To: Village of Orland Park Address: 14700 South Ravinia Avenue Orland Park, Illinois 60462	Contact: Khurshid Hoda Phone: 708-403-6128 Email: khoda@orlandpark.org
Project Name: John Humphrey Sports Complex Renovation Location: Orland Park, Illinois	Ref #: CG19013 Date: 8/26/2019

V3 Construction Group, Ltd. proposes to execute the following work:

CHANGE ORDER PROPOSAL #2				TOTAL
2.10	PCC REPLACEMENT - CONCESSION BUILDING			\$ 25,400.00
2.20	BARRIER CURB AROUND 1-4 BACKSTOPS			\$ 25,750.00
2.40	PCC COLLAR - STRUCTURES			\$ 3,300.00
2.51	FIELD 4 RETAINING WALL; 3' TALL			\$ 55,185.00
2.60	OUTFALL PIPE INSTALLATION			\$ 9,200.00
2.70	IRRIGATION - FOOTBALL ZONING & HEAD SPACING			\$ 20,846.00
2.80	PAINT LIGHT POLES			\$ 67,142.00
2.90	WATER SERVICE TO BUILDING; 4" DIP			\$ 40,759.00
3.00	3" WATER METER			\$ 1,226.00
3.10	IRRIGATION PUMP			\$ 13,516.00
PROPOSAL TOTAL:				\$ 262,324.00

Option 2.1 - Concession Building
Concrete

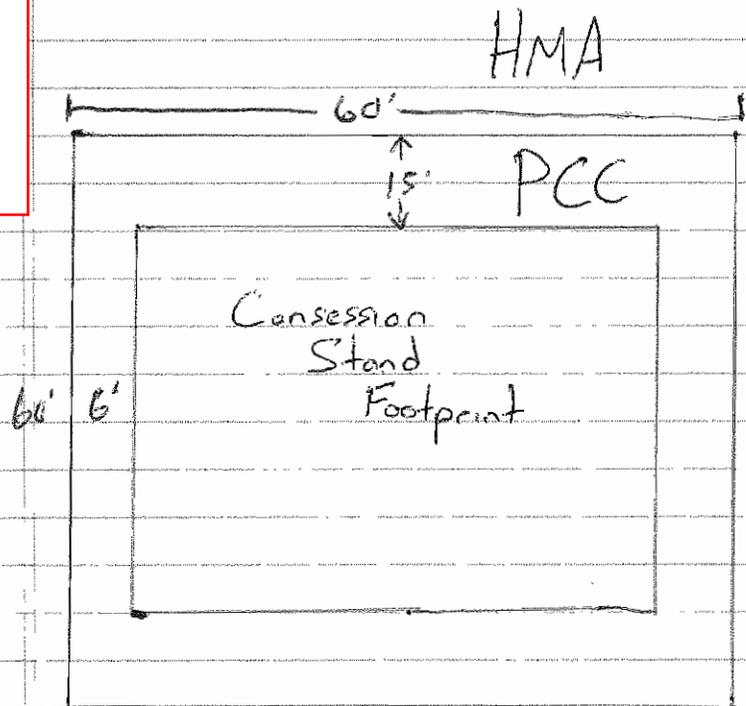
Concrete being removed and replaced
around the concession stand in it's
entirety

$$60 \times 15 = 900 \times 2 = 1800$$

$$30 \times 6 = 180 \times 2 = 360 = 2,160 \text{ SF}$$

Option 2.6 - Outfall Pipe Revision

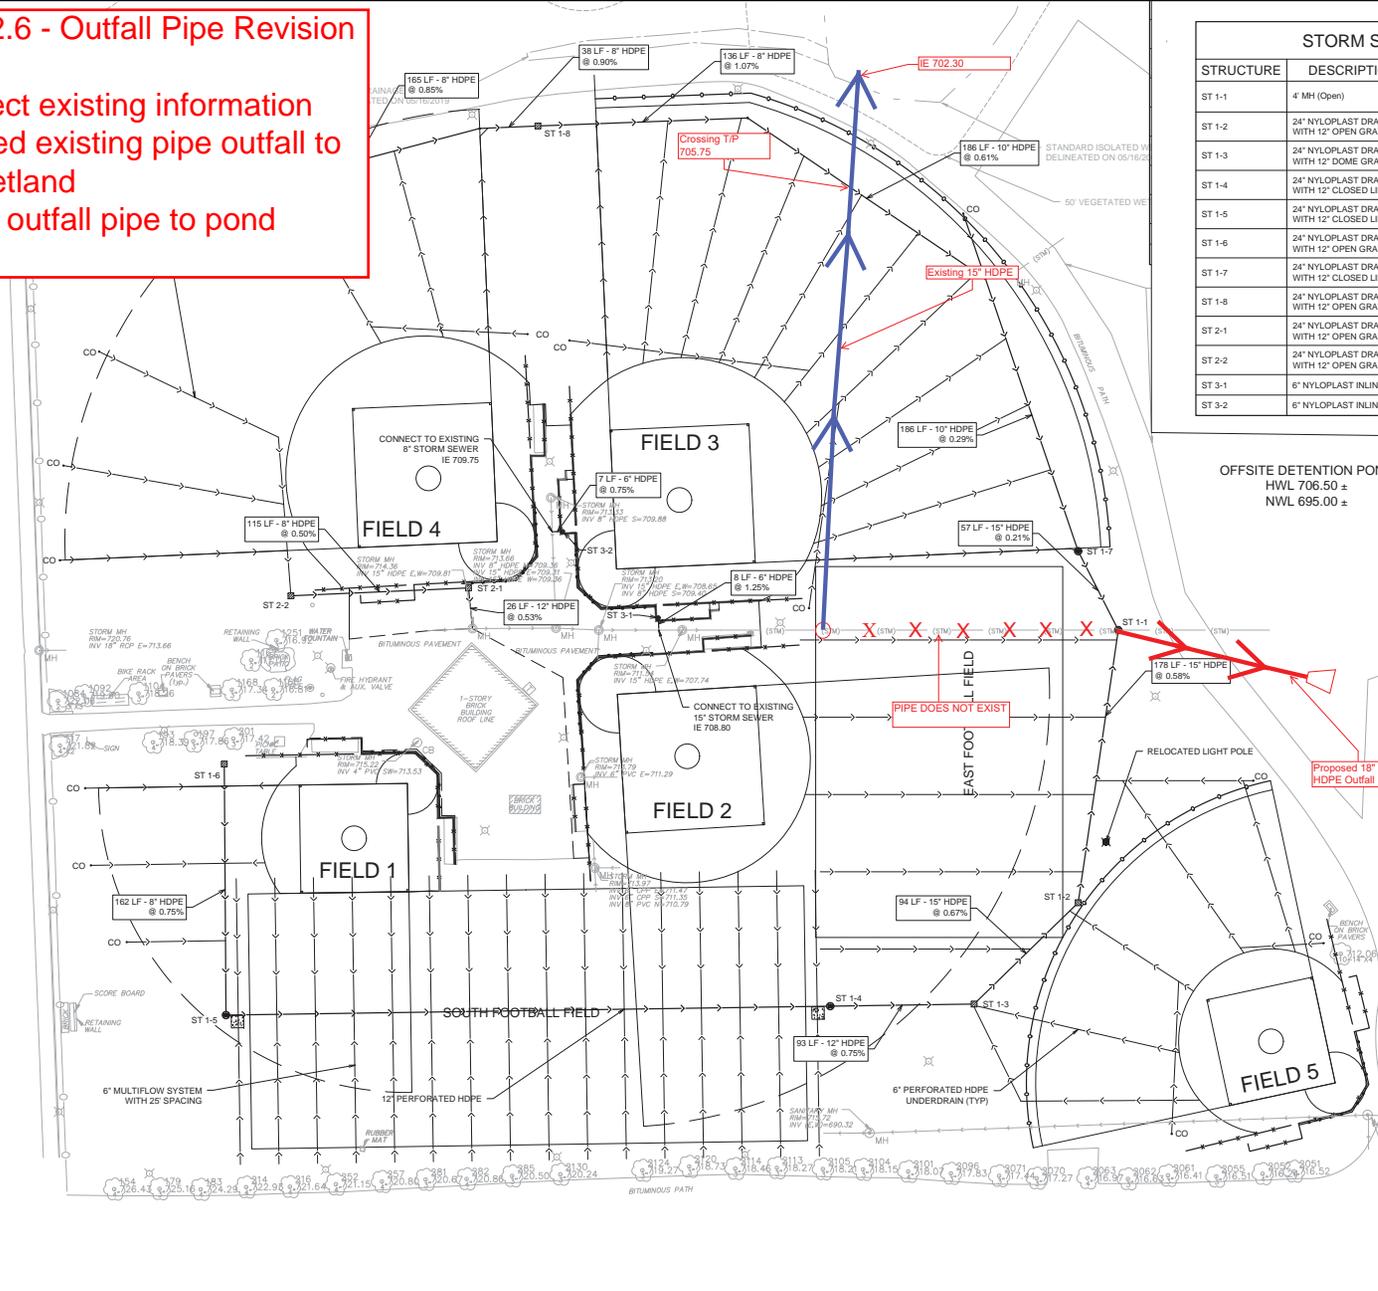
- * Incorrect existing information
- * Updated existing pipe outfall to north wetland
- * Added outfall pipe to pond

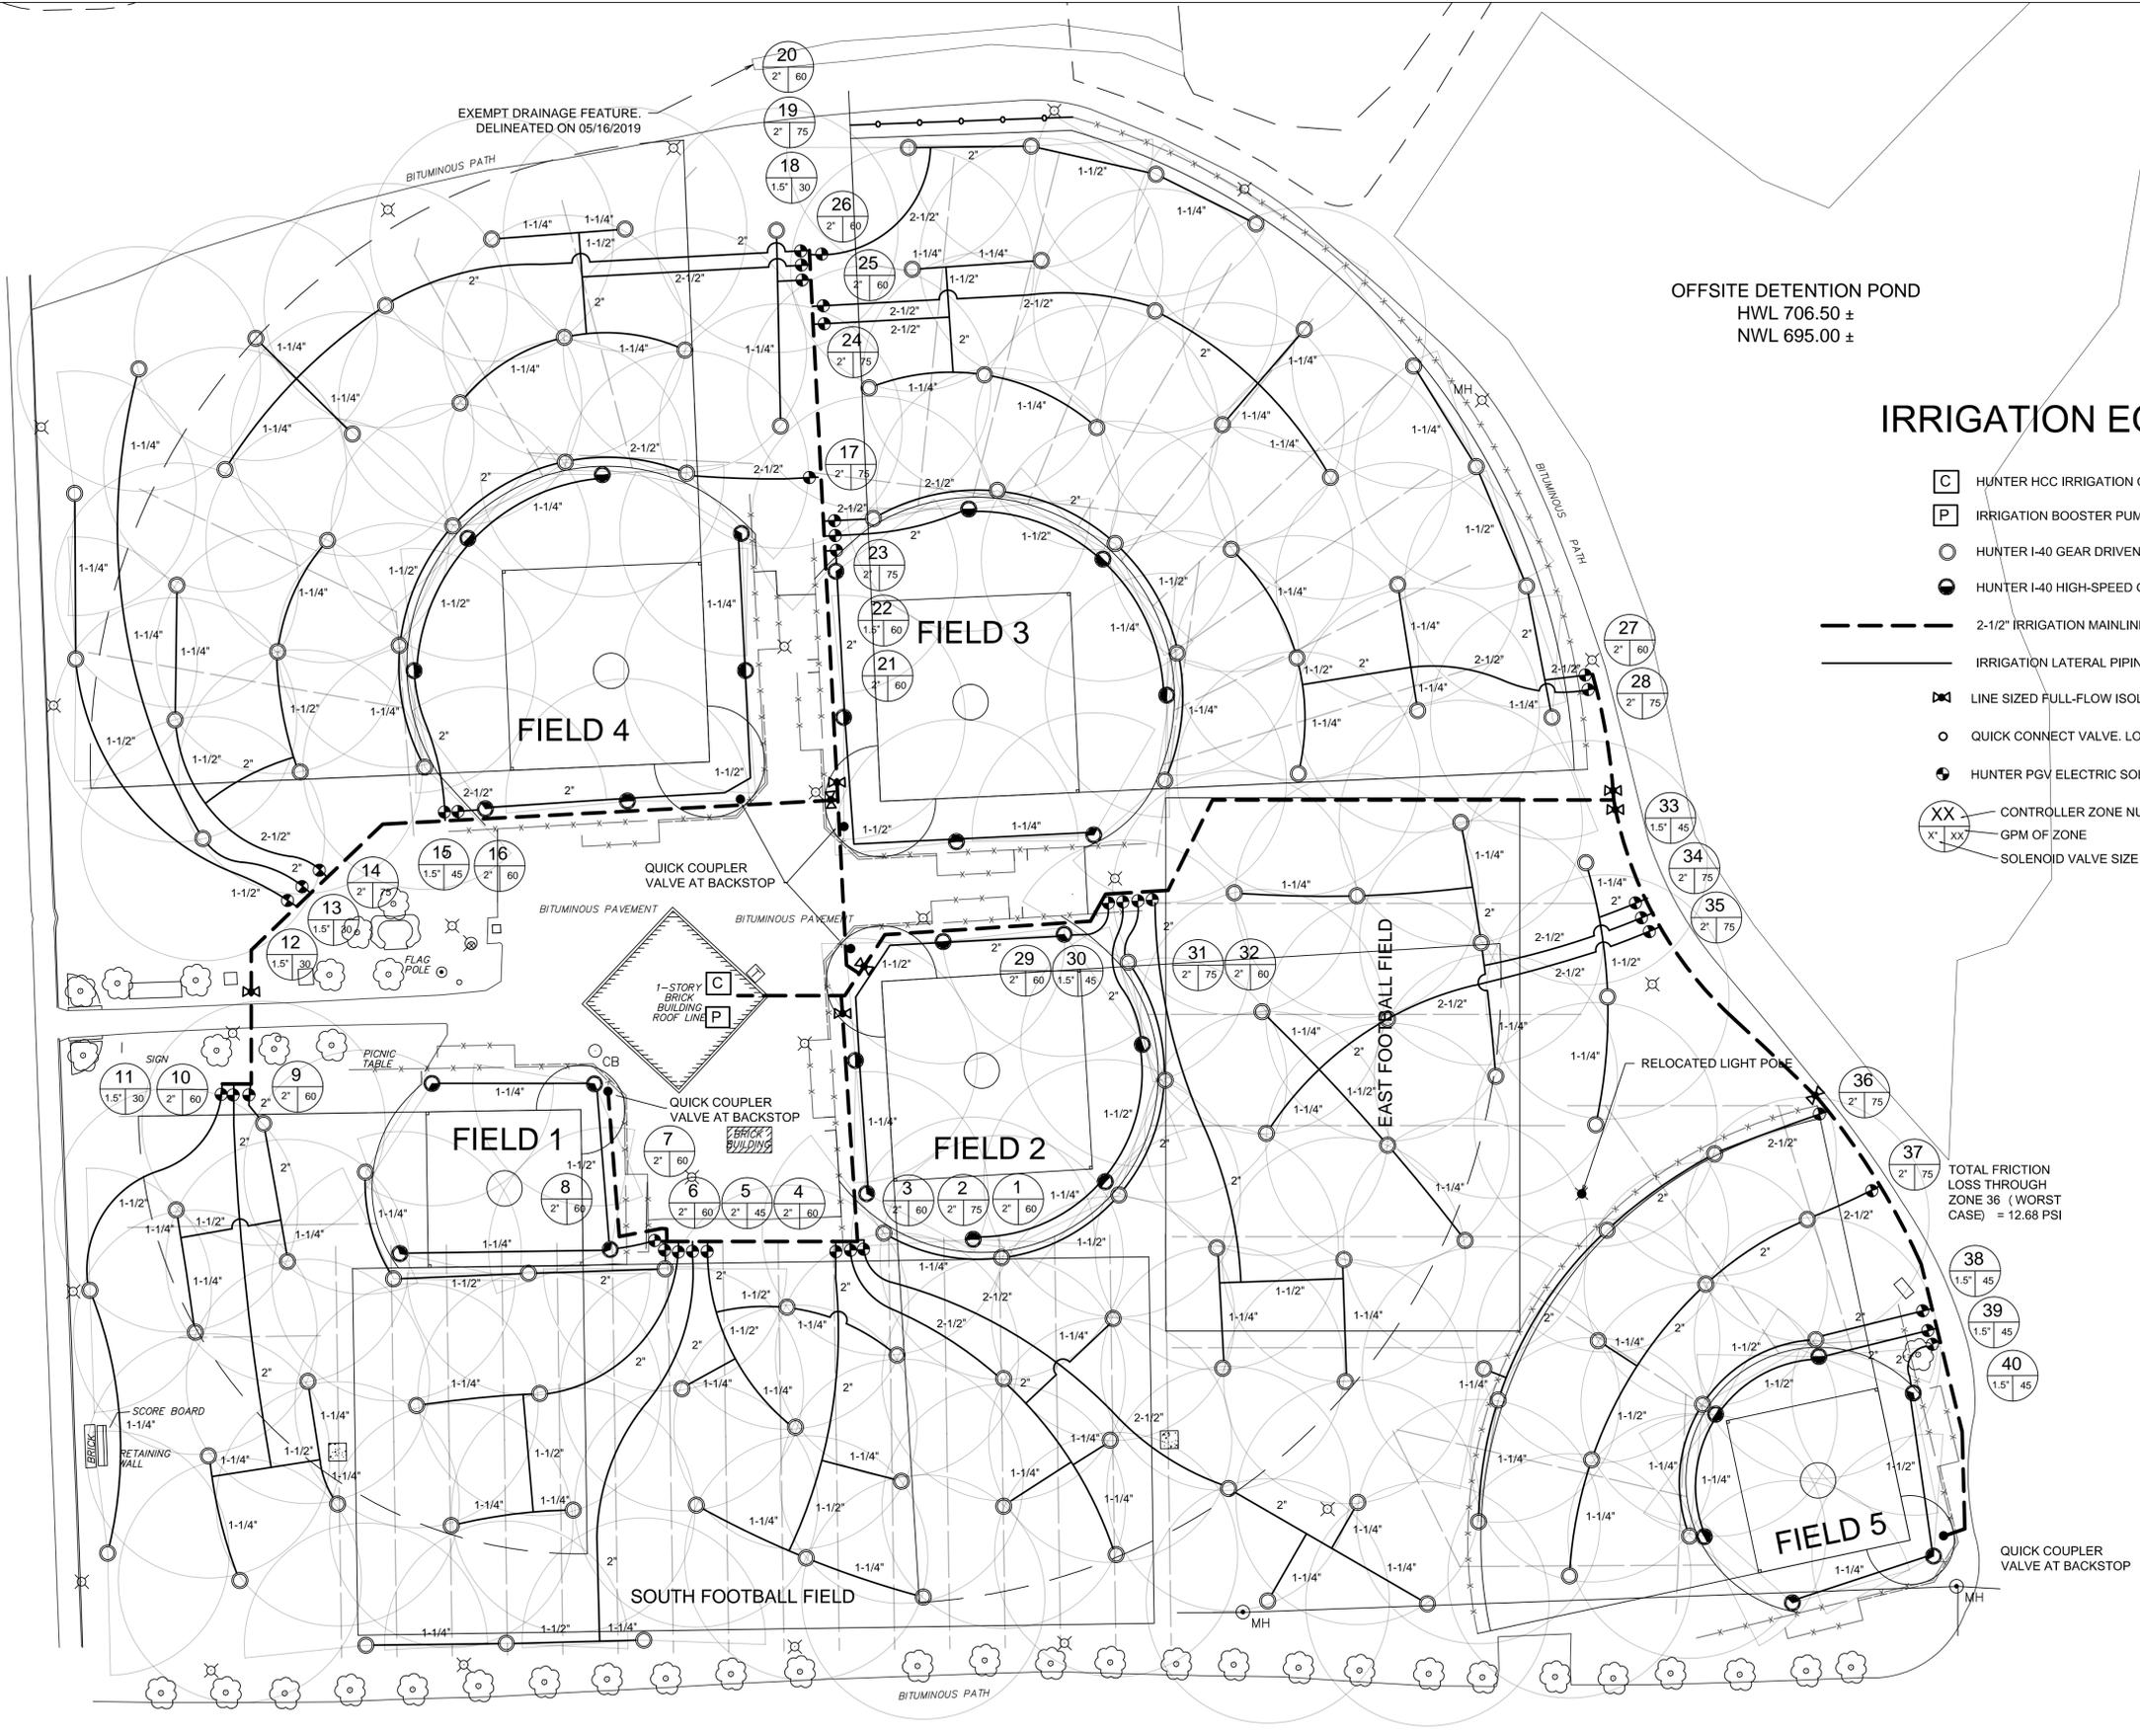
Provide and install new vault for 4" vault **\$4,300.00**

Install and program flow meter for the Hunter HCC control system **\$4,125.00**

Install a 208volt to 230v rated 3ph packaged Grundfos pumping with VFD system this pumping system can drop to 190v. **\$5,091.00**

This manufactured packaged pump system replaces the 230volt rated system component built system that will fault out at 200volt. (I am only charging the cost difference between the two pumping systems.

We are installing for irrigation 4" ductile from concession building to first field in lieu of 2-1/2" PVC. We are oversizing pipe just in case expansion of system is ever needed or if multiple valves need to operate. Installing Ductile in lieu of PVC will be much more robust especially under hardsape surface and initial piping discharge under building. **(NO CHARGE)**

Option 2.8 - Paint Existing Light Poles

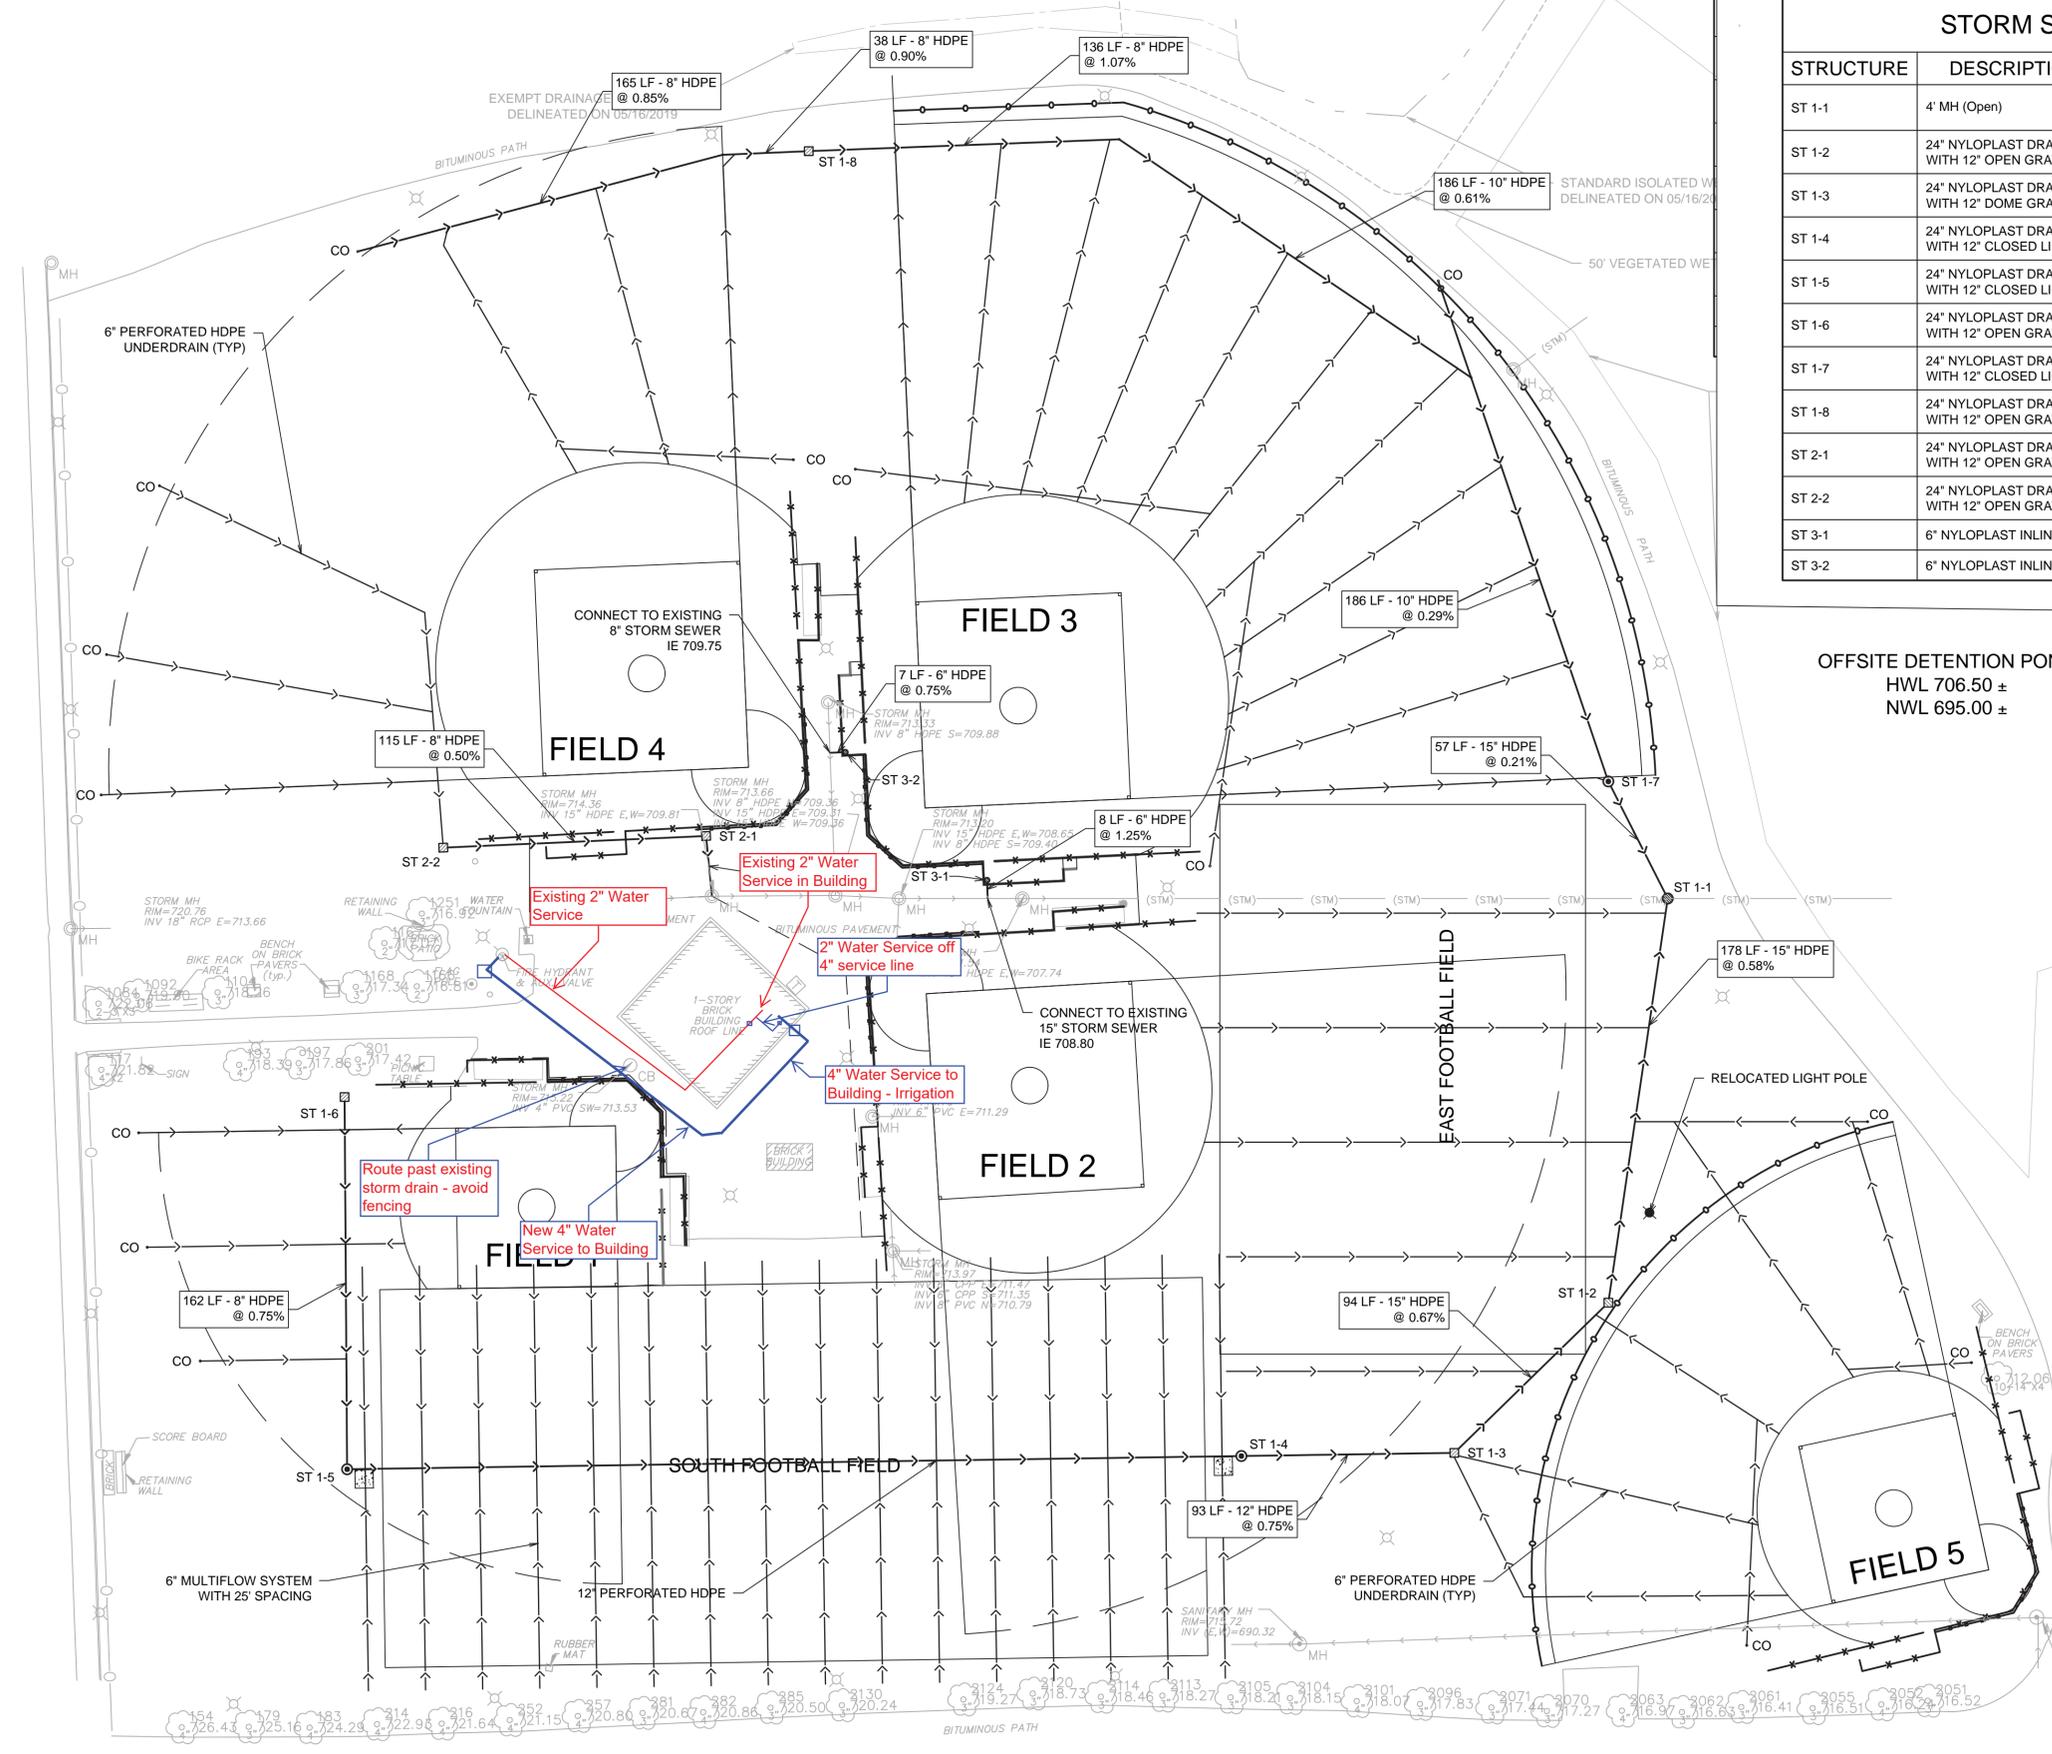
- * Nine (9) poles identified within the interior of the complex
- * Poles to be cleaned and painted
- * No perimeter poles currently included in this option but can be added upon

- 1) All poles will be painted in place
- 2) Poles will be cleaned by power washing (min 2,000 psi)
- 3) Poles will be scraped to remove loose material (wire brush and/or hand-held tool)
- 4) Poles with areas of rust will be wire brushed or sanded
- 5) Bare surfaces will be primed with metal primer
- 6) Finish coat of a high-performance acrylic, high gloss black paint will be applied
- 7) Thorne Electric will provide a one-year warranty to include manufacturers defects and any cracking or spalling of paint.
- 8) Warranty begins upon completion of the pole painting and Village acceptance of work.
- 9) Schedule if for pole painting to be complete by November 1, 2019.
